# Access Compliance Report

## Public Rights-of-Way

### (Curb Ramps)

Intersection ID: 10023159	Main Street: CHARLOTTE_VIEW_DR	Cross Street: N/A	Location: SE
ADA ID: 101926A1FABC	Ramp Type: Perp	Initial Pass/Fail: Fail	Overall Compliance: No
		Severity Score: 25

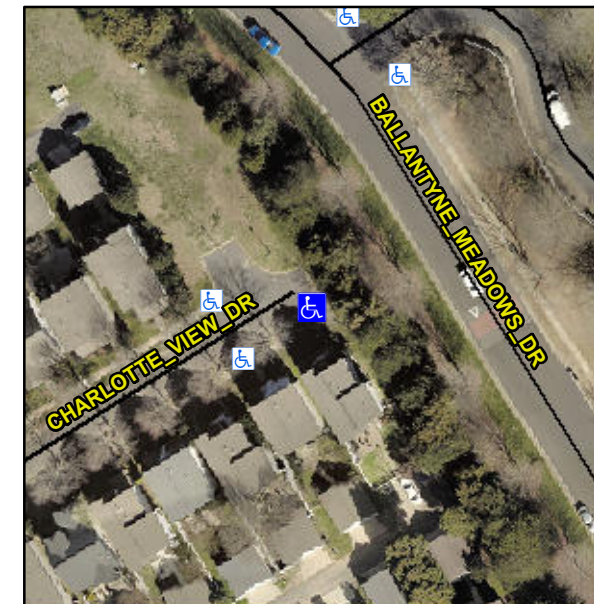
Compliance	Description	Data	Compliance	Description	Data
N/A	Ramp Length (in)	48.0	No	Ramp Slope (%)	15.4
Yes	Ramp Width (in)	48.0	Yes	Ramp XSlope (%)	0.1
N/A	Flare Type LT	N/A	N/A	Flare Type RT	N/A
N/A	Flare Slope LT (%)	N/A	N/A	Flare Slope RT (%)	N/A
N/A	Flare Traversable LT?	N/A	N/A	Flare Traversable RT?	N/A
N/A	Landing Length (in)	N/A	N/A	DWS Provided?	N/A
N/A	Landing Width (in)	N/A	N/A	DWS Contrast?	N/A
N/A	Landing Slope (%)	N/A	N/A	DWS Length (in)	N/A
N/A	Landing X Slope (%)	N/A	N/A	DWS Full Width?	N/A
N/A	Landing Curb? (Y/N)	N/A	N/A	DWS Offset (in)	N/A
N/A	Shared Landing?	N/A			
N/A	Gutter Ponding?	N/A	N/A	Gutter Slope (%)	N/A
N/A	Gutter Lip Ht (in)	N/A	N/A	Gutter X Slope (%)	N/A
N/A	Painted X Walk1?	No	N/A	Painted X Walk2?	N/A
	X Walk 1 Direction	To NW		X Walk 2 Direction	N/A
N/A	X Walk 1 Width (in)	N/A	N/A	X Walk 2 Width (in)	N/A
	X Walk 1 Slope (%)	1.5		X Walk 2 Slope (%)	N/A
	X Walk 1 X Slope (%)	1.5		X Walk 2 X Slope (%)	N/A

**Remove & Replace Entire Ramp.**

**R304.2.2**
